Regulatory Docket File

Re Indian Point Unit No. 3
Docket No. 50-286

Your letter dated July 22, 1975 requested additional information in order to assess the adequacy of the reactor vessel support system for a double-ended break in the reactor coolant system cold leg pipe at the reactor vessel nozzle. By letter dated July 30, 1975, we indicated that the information requested in Items 1 and 2 would be provided by August 15, 1975. By letter dated August 15, 1975, we forwarded the information requested in Item 1 for your consideration and also indicated that the response to Item 2 would be provided by August 29, 1975.

TABLE 1

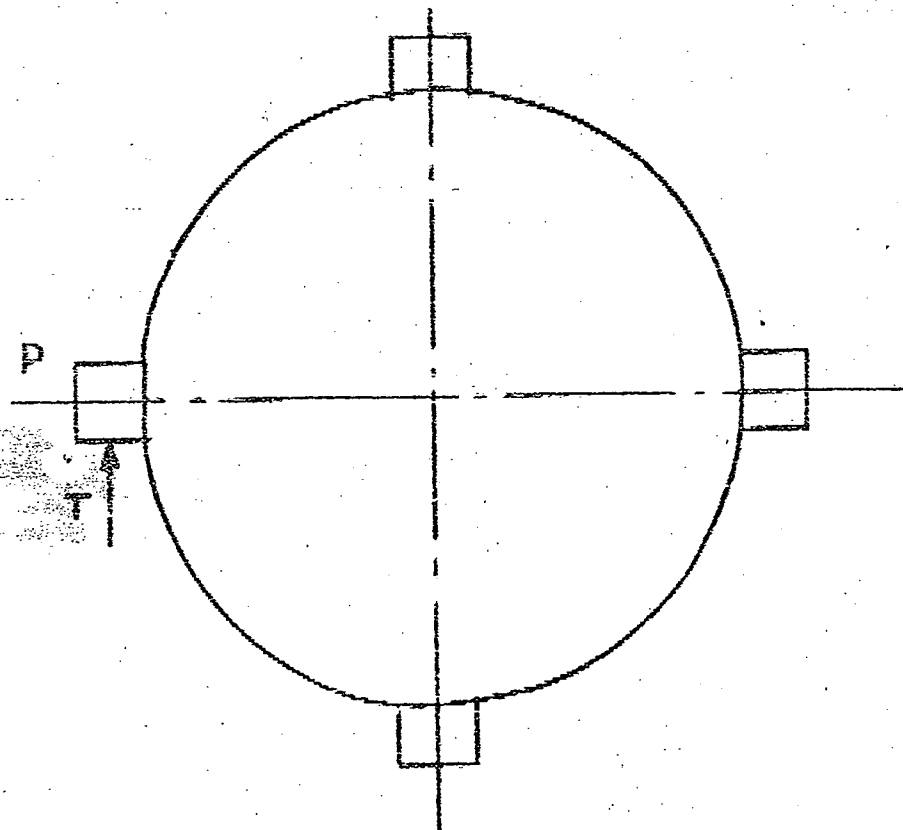
Table 1 shows the maximum loads and combined loads derived from the application of this criteria to the reactor vessel supports. These loads are applied in the analysis to each individual support. Since the applied lateral loads on the reactor vessel are resisted by two support shoes, the total lateral load applied to the reactor vessel is twice that applied to each shoe. The highest lateral load the reactor vessel will see given the above described design basis is 2444 kips. The steam generator supports and the reactor coolant pump supports attached to the unbroken loops also resist the applied lateral loads. This effect which was conservatively not included, is significant as it will reduce the loads transferred to the vessel support, since the total loads would be redistributed to all the supports.

The concrete wall was designed to the requirements of the 1963 American Concrete Institute Code (ACI). For the applied loads in Table 1, the maximum bearing stress in the concrete is calculated to be 530 psi. This occurred in the concrete under the ring girder. The ACI allowable bearing stress for combined seismic plus pipe loads is 2700 psi.

The ring girder was designed to the requirements of the 1963 American Institute of Steel Construction Code (AISC). For the applied loads in Table 1, the maximum stress is calculated to be 31.8 ksi in the top beam of the ring girder on the edge away from the reactor vessel. The AISC allowable stress for non-normal loading conditions usually associated with plant emergency conditions is 32 ksi ($.9f_y$). The extreme loadings of the pipe rupture are, therefore, below this stress limit used for the upset condition. The yield stress of the ring girder material is approximately 36 ksi.

The reactor vessel shoe was designed to the requirement of the AISC Code, also. For the applied loads, the maximum stress was a shear stress in the pins between the shoe and the cooling plate/ring girder assembly. The shear stress in these pins was 54 ksi which can be compared to a shear yield stress ($f_y/\sqrt{3}$) of 75 ksi. This is the

Figure Q4.30a-1 Reactor Coolant Loop Postulated Break Locations

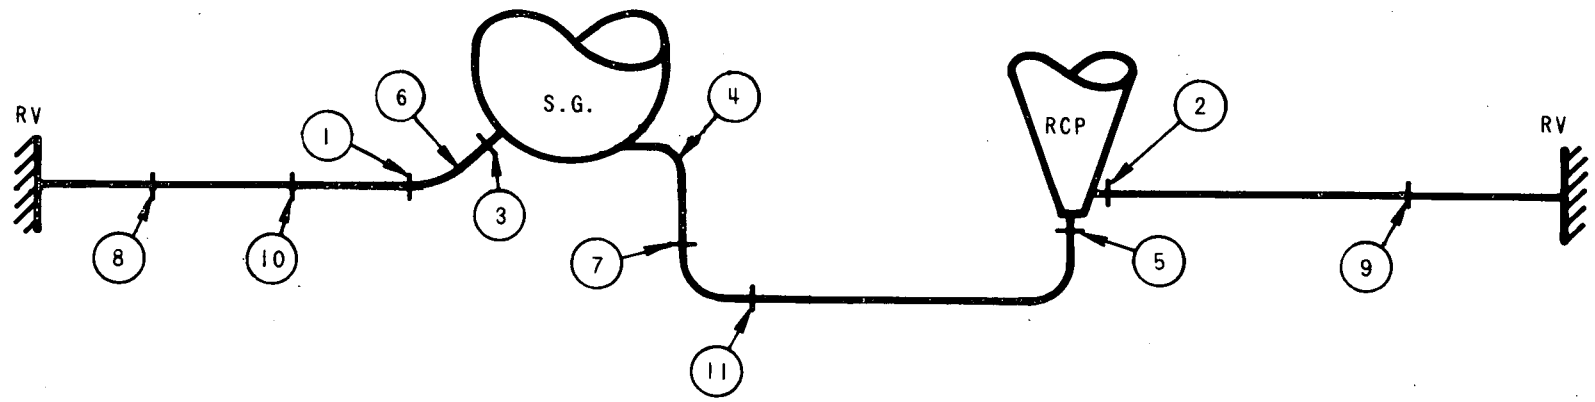
The basis for the design of the Indian Point 3 reactor vessel support system included consideration of breaks outside the primary shield wall. These break locations are shown in attached FSAR Figure 04.30a-1. Break locations 1 and 2 on this figure, which are postulated as double-ended breaks at the juncture of the hot leg and elbow entering the steam generator and at the reactor coolant pump discharge respectively, are the most significant, as they induce the highest loading on the reactor vessel supports. Break locations 8,9 and 10, although nearer to the vessel, are less severe than break locations 1 or 2 because they are postulated ruptures in the attached branch lines with opening areas much less than a double-ended rupture of the primary loop.
